ELECTRONIC CALCULATOR 130

SERVICE LETTER

SUBJECT: Plug-in Circuit Card Jacks (Friden No. 803206)

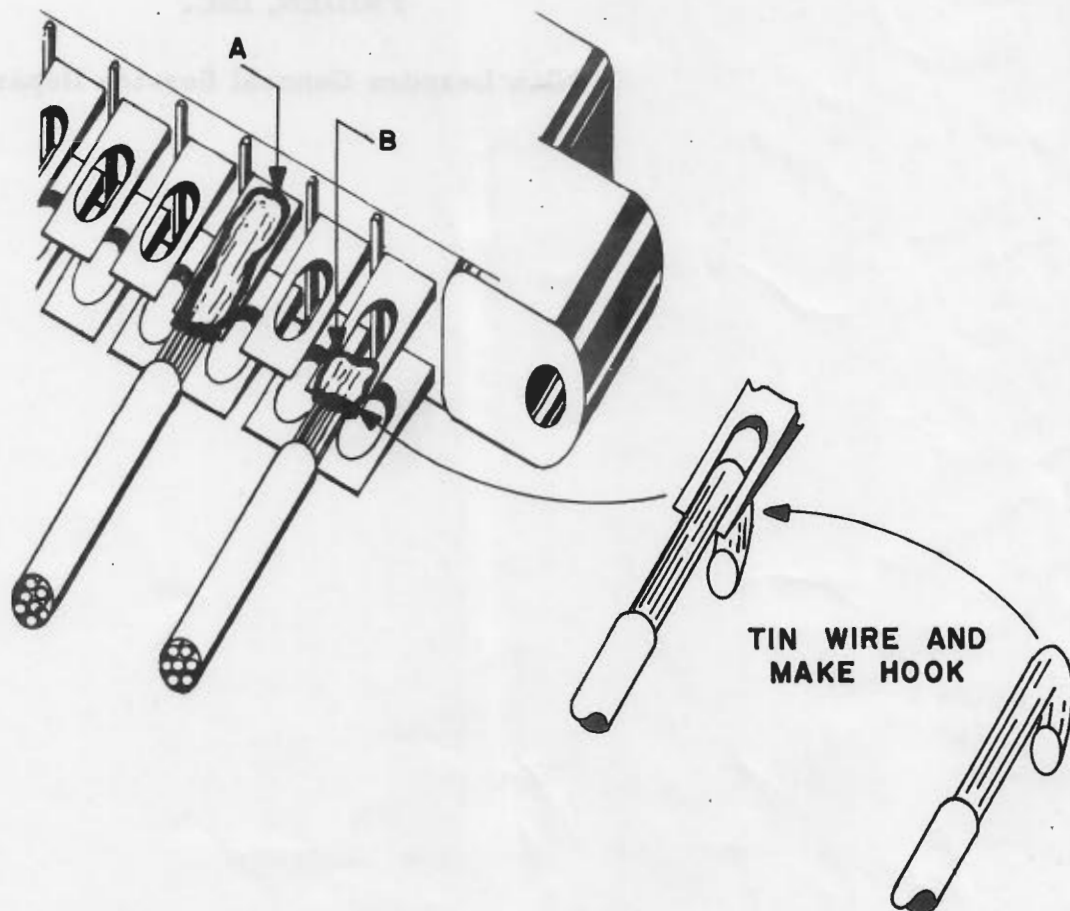
REASON: Intermittent troubles have been traced to bad plug-in card jacks on some machines in the group serialized 1040-1090 (approximately).

INSTRUCTIONS: Replace jacks if intermittent operation results when pressing on a plug-in card or if servicing indicates trouble in jacks.

Point A illustrates soldering technique that is causing trouble. Point B illustrates method to be used when replacing a plug-in card jack.

When replacing a jack, the new jack should be placed alongside bad jack and leads transferred one by one to corresponding terminals. Otherwise, each lead will have to be tagged since these wires have no number coding.

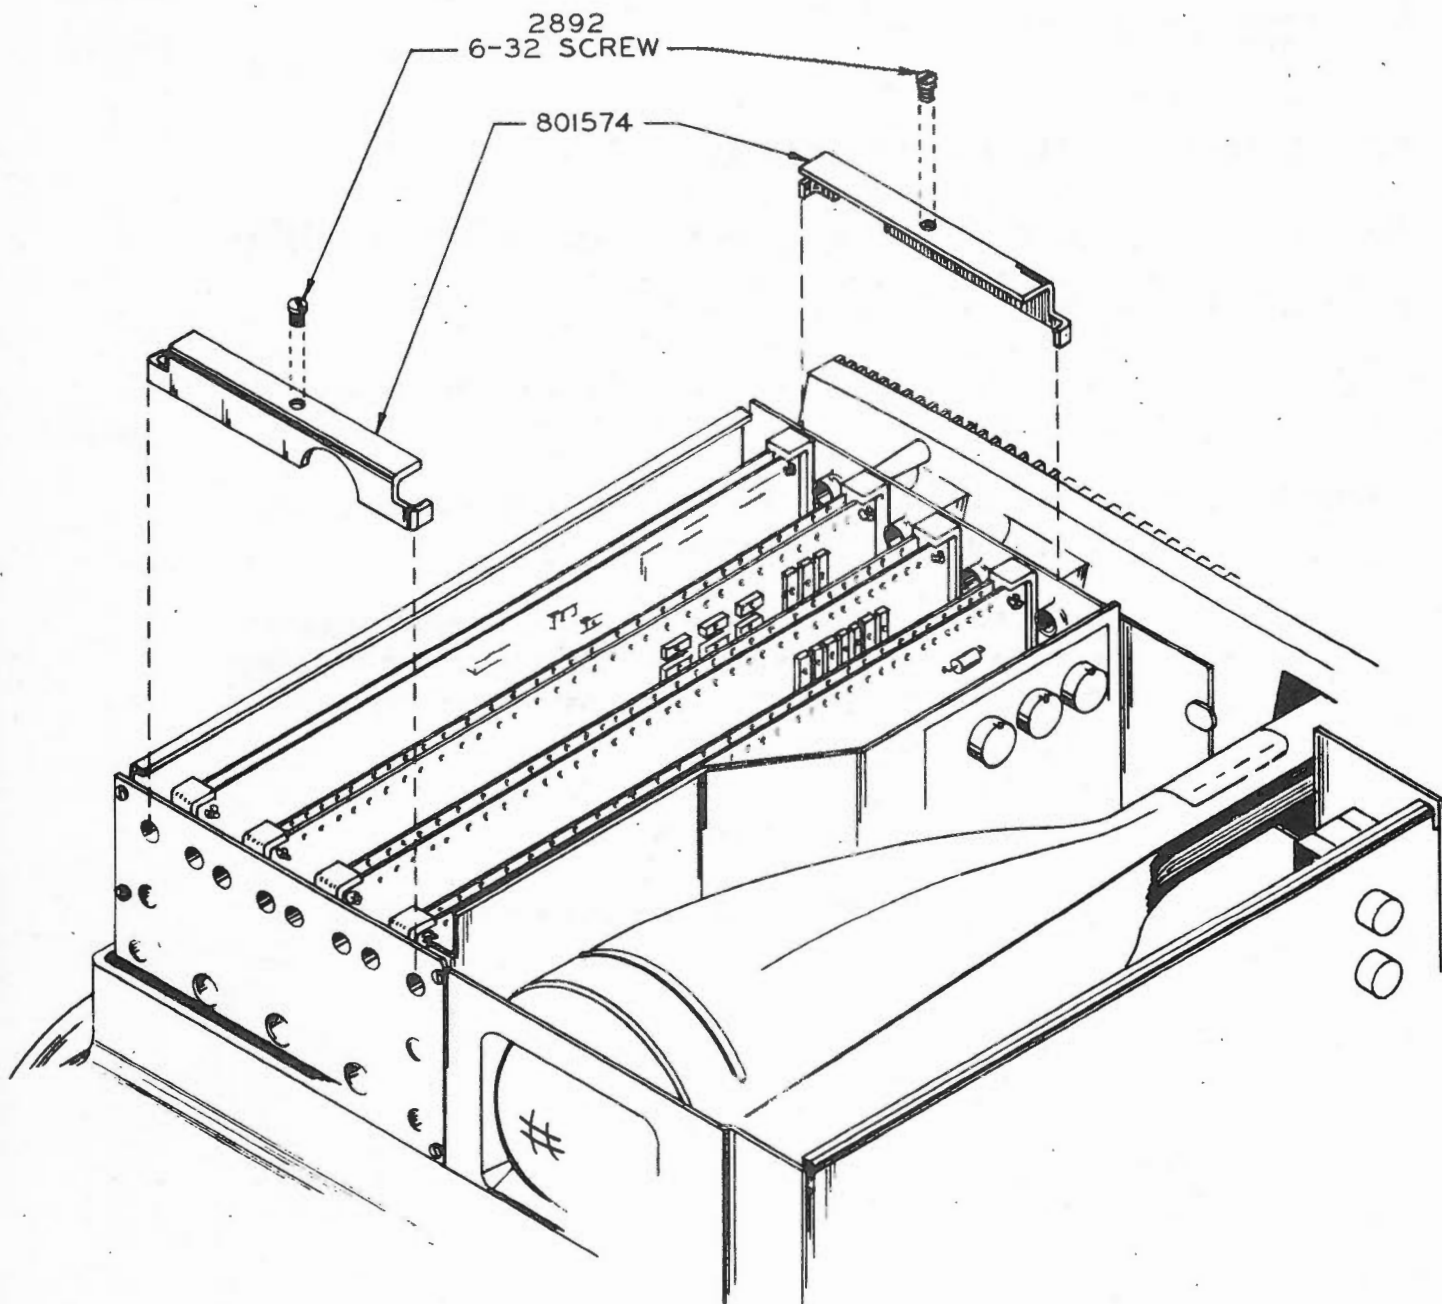
REASON: Present installation of only one card retaining plate is unsatisfactory.

INSTRUCTIONS: Remove present retaining plate and replace with double retaining plates as per sketch.

NOTE: In cases of extreme difference in card heights, it may be necessary to cut a slit(s) in the lip of the plate and form the lip up or down for a particular card, or cards.

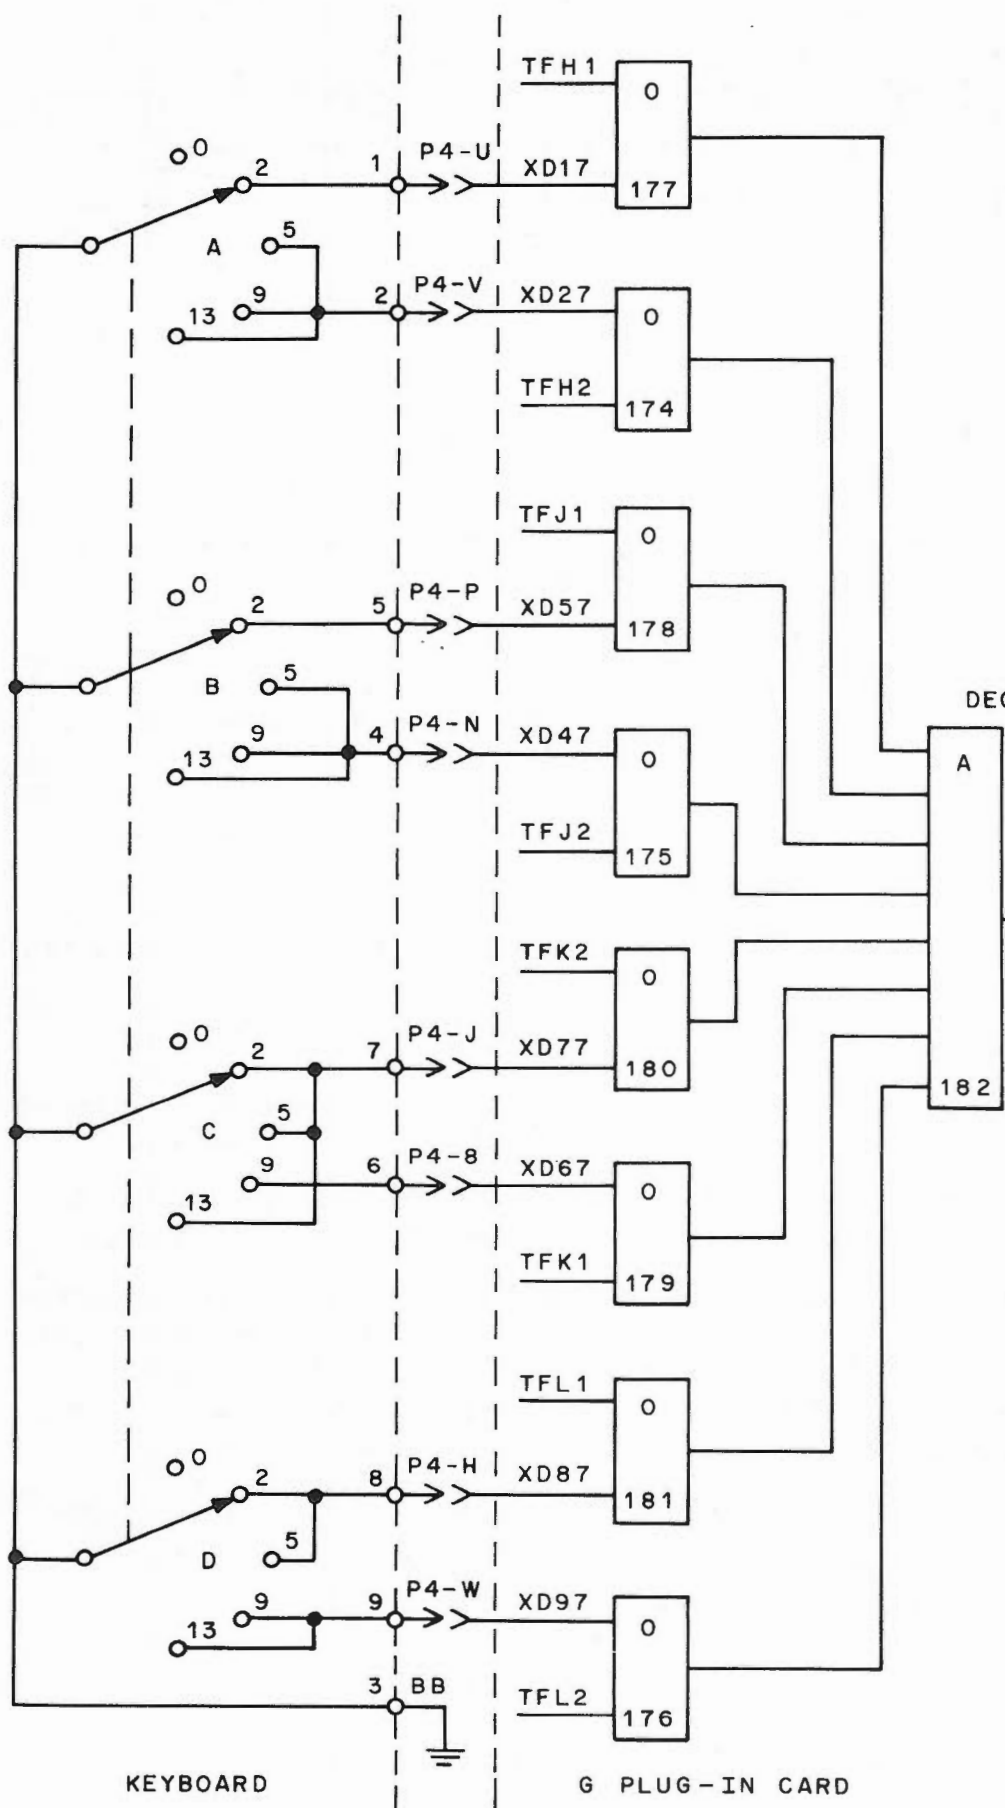
SUBJECT: Decimal Switch, Position 0-2-5-9-13.

REASON: Due to customer's application, a "9" position decimal setting may be required.

1. Remove keyboard.
2. Remove printed circuit board.
3. Loosen the two (2) allen head screws and remove the gear from the decimal switch shaft.
4. Remove screws holding pin plug assembly.
5. Remove nut holding switch assembly and remove switch assembly.
6. Install new switch assembly, reversing procedure of Steps 3, 4, 5. The decimal switch should be in position "0" or "13" when reassembling.
7. Replace decimal switch indicator with new indicator.
8. Install printed circuit board.
9. Install keyboard and reconnect wiring. Check the position of the decimal switch indicator before final tightening up.

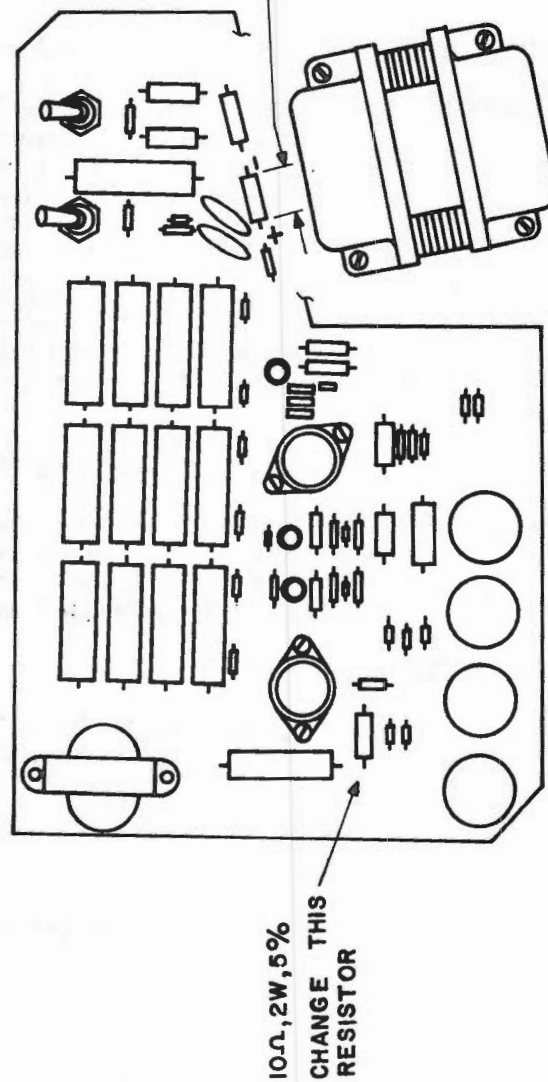
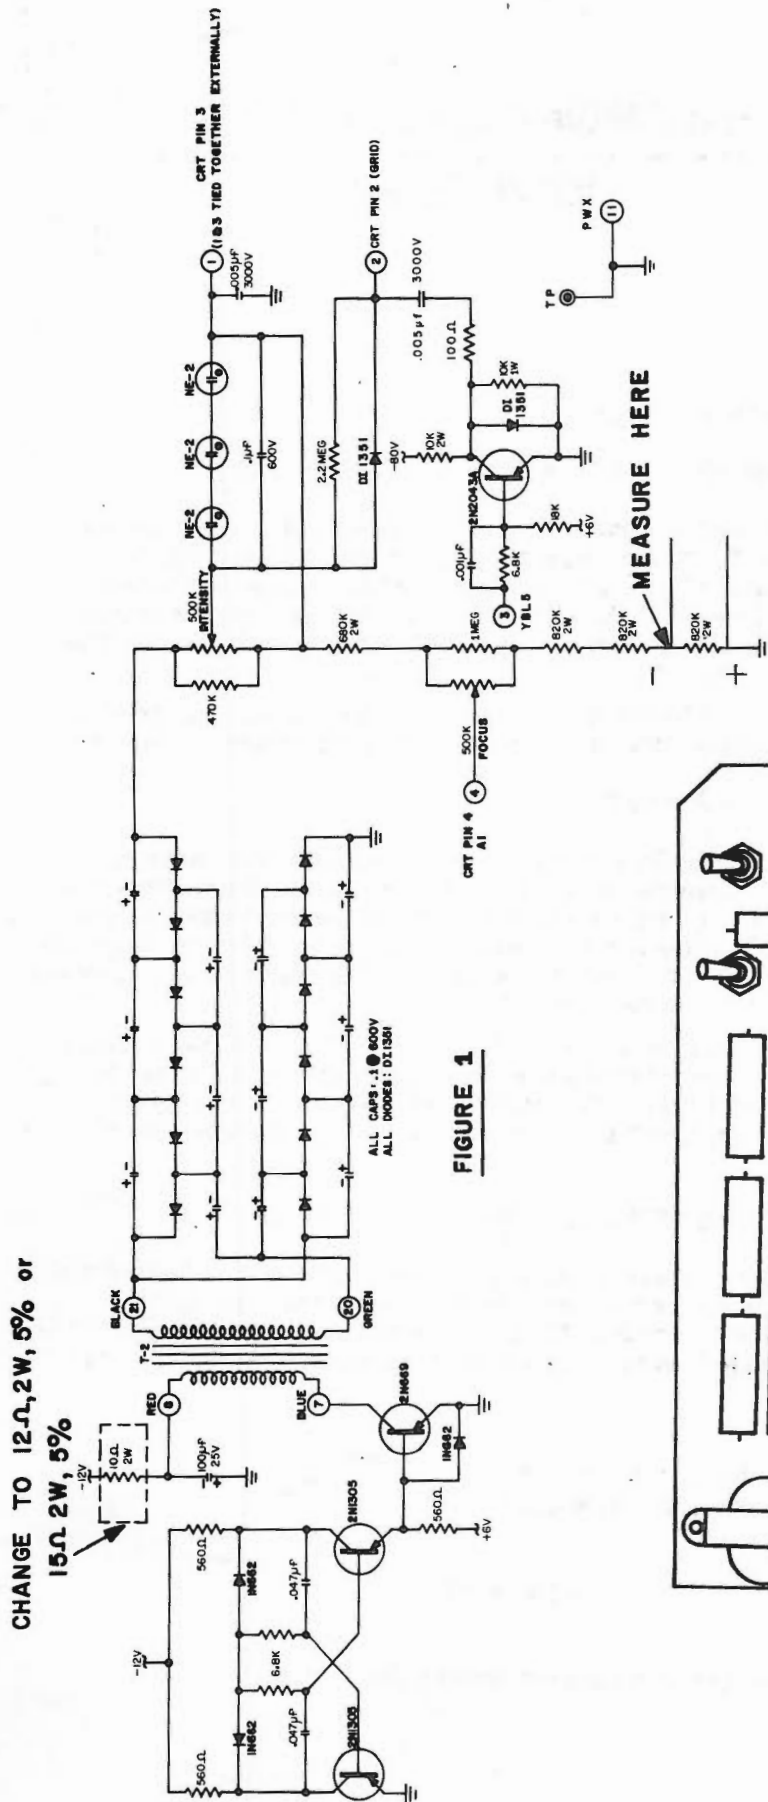
MODIFY: EC-130/132 Calculators with high voltage exceeding 2500V.

REASON: The high voltage supply, common to both models, is dependent on several factors; -12V supply, decoupling network, oscillator frequency, and symmetry, leakage in the multiplier sections, and tolerances within the resistor bleeder chain. Each of these can be within its own tolerance, but collectively they can cause the high voltage to exceed -2500V. The nominal voltage ranges from -2200V to -2400V.

High voltage above -2500V may cause arcing within the CRT. This, as you know, can cause destruction of the associated transistor circuitry.

INSTRUCTION: Using a Triplet Model 310 volt meter set on the 1200 VDC scale measure across the bottom resistor in the high voltage bleeder chain. This resistor 820K-2W (gray, red, yellow, and gold) is the one closest to the power transformer. The resistor lead nearer the transformer is ground and must have the positive lead of the meter. The negative lead connects to the other end of the same resistor.

If the measured voltage is above -560 volts but below -580 volts, replace the 10 ohm, 2W, 5% resistor (located in the primary circuit of the high voltage transformer) with a 12 ohm, 2W, 5% resistor. If voltage is above -580 volts, replace the 10 ohm resistor with a 15 ohm, 2W, 5% resistor.

CAUTION: You will be working with an uncommonly HIGH VOLTAGE; 1500 volts if you get across the wrong resistor. Observe that there are three identical 820K, 2W resistors. The one across which the measurement is to be taken is located nearest the power transformer. Refer to Figure 2.

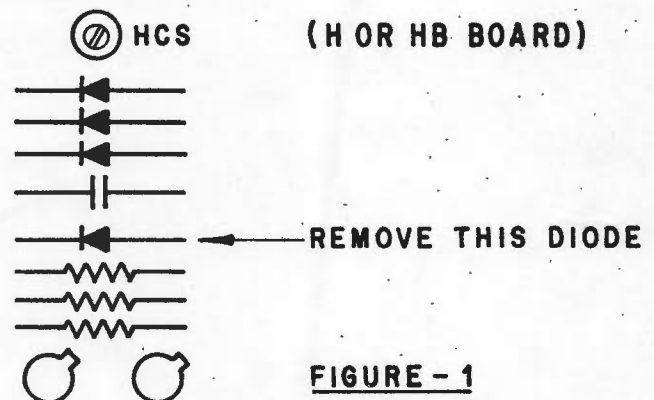
REASON: To eliminate "wavering display" by changing the data writing rate and bringing voltage within tolerance.

Remove the diode indicated in Figure 1. This is referenced in the EC-130 construction file under 1580.020.0 and in the EC-132 construction file under 1600.021.0. Removal of this diode will eliminate one writing pass of R1 so that R1 will be of the same intensity as R2, R3, and R4. Readjustment of the intensity control may be required. If "wavering" still persists, replace old style power transformer with new style transformer. The old style transformer has the part number (804002) stamped into the side, while the new transformer has the number on the top. The new transformer must be installed in the same position as the present one with the laminations approximately parallel to the side frame, or additional "waving" may be created.

FIGURE 1

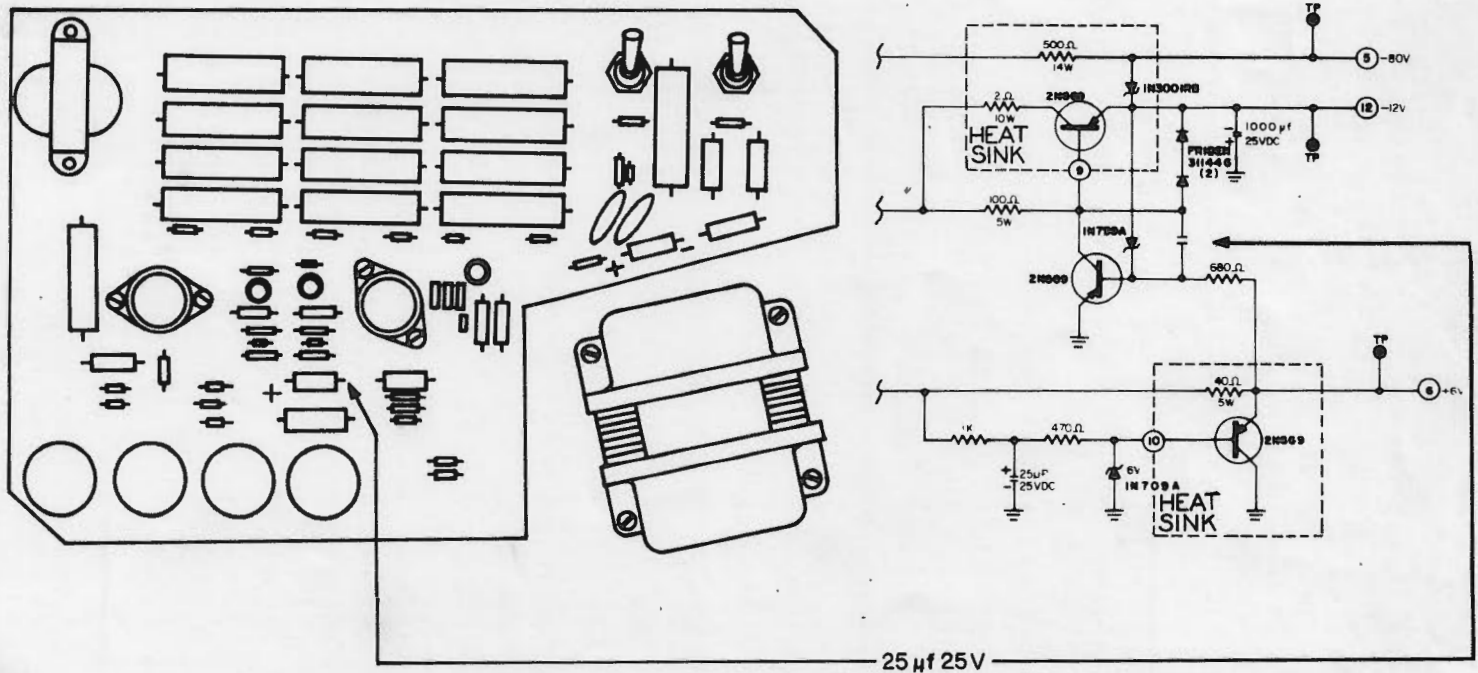
INSTRUCTIONS: Replace the .1 μ f 200V capacitor (804096) on the power supply board with a 25 μ f 25V capacitor (804102). The new capacitor must be installed with the positive (+) end to the front of the machine.

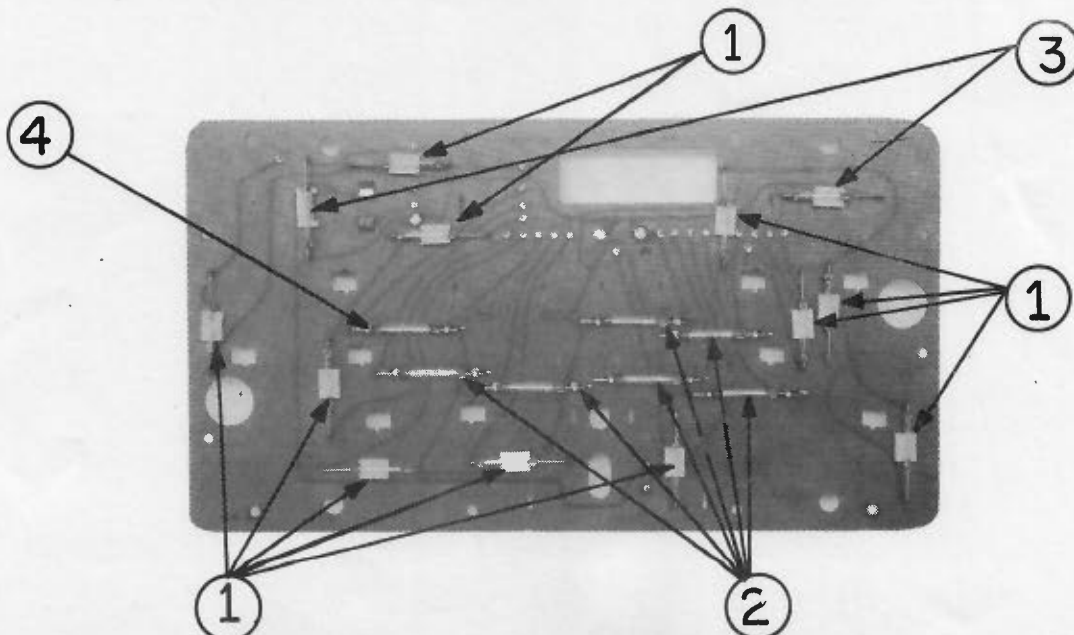
REASON: A new reed switch, with improved magnetic characteristics, is being installed in all but two of the function positions. The new switch is physically smaller than the old style and does not have a dot painted on one end.

INSTRUCTIONS: When installing these new switches, particular attention must be paid so that the long formed lead of the new switch is placed in the same position as the long formed lead of the old switch.

New switch part #810044 used in positions 6-8-9-10-11-12-13-14-15-17-25. Shown as #1 in photo.

FIGURE 1
PIN CONNECTIONS
EARLY KBD
1016 thru 4903

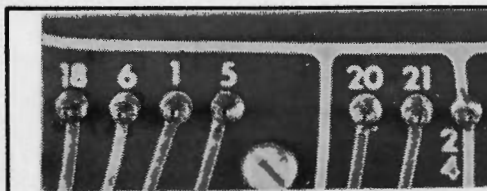
REASON: To provide interchangeability of EC-130 keyboards for machines serial #1016 to 4904, from 4905 to 8500 and 8500 and up. (Note three different keyboards.)

1. Keyboard 1016 - 4904, basic keyboard, see Figure 1.
2. Keyboard printed circuit board was changed at serial #4905 see Figure 2.
3. Decimal point switch was changed at serial #8500, and still used printed circuit board as shown in Figure 2.

FIGURE A

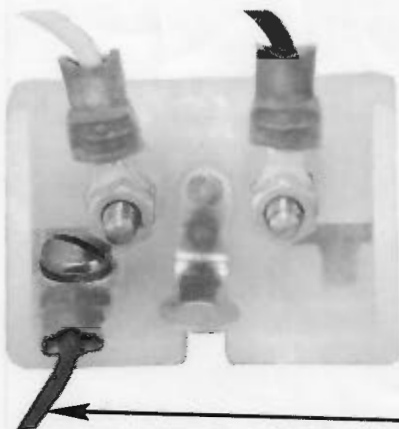
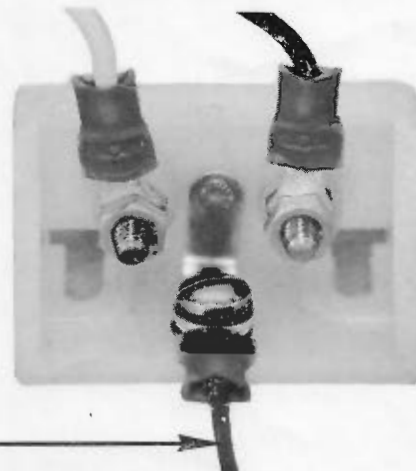
INSTRUCTIONS: Remove the cover. Remove the two screws securing the heat sink and swing the heat sink down. Remove the left mounting screw which presently secures the green ground wire and remove the green wire (see Figure A).

Re-install the green wire under the center mounting screw (see Figure B).
